**DUKE POWER COMPANY**

November 30, 1984

Subject: McGuire Nuclear Station - Docket No. 50-369/370  
Catawba Nuclear Station - Docket No. 50-413/414  
Response Request for Additional Information Regarding  
Topical Report DPC-NF-2010, "Nuclear Physics Methodology  
for Reload Design"

FIGURE 5.3

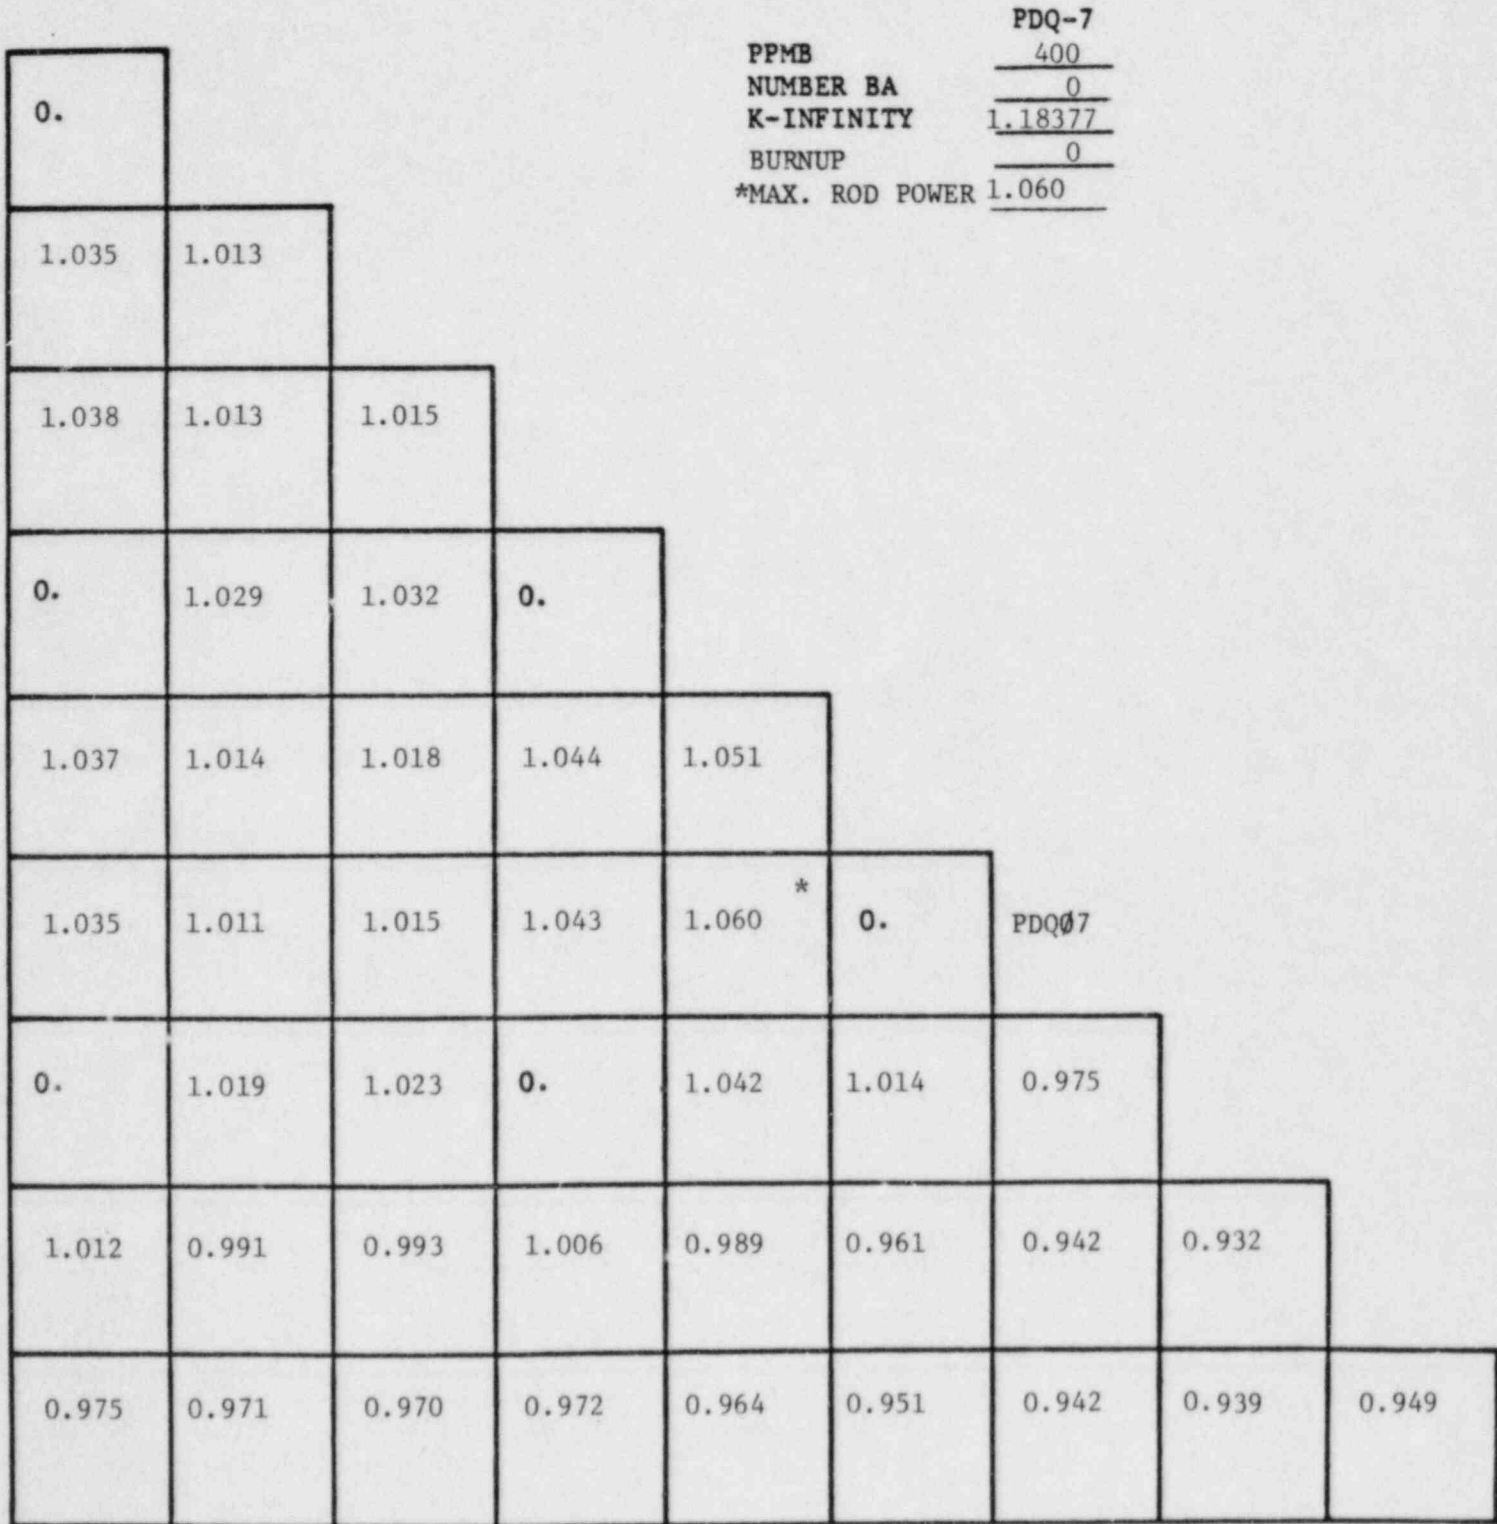
Duke Power has performed the requested calculations on the BNL benchmark assembly problem using EPRI-CELL/PDQ07. The results of those calculations are attached. Figures 5.3 through 5.16 present PDQ07 calculated rod powers for the non-rodded and 16 BP cases. Table 5.1 presents rod power summary data for these analyses. Table 5.2 presents summary reactivity information as requested in section II of the benchmark problem. In accordance with the Duke-NRC telephone agreement, data for items I.2 through I.5 of the problem will not be presented.
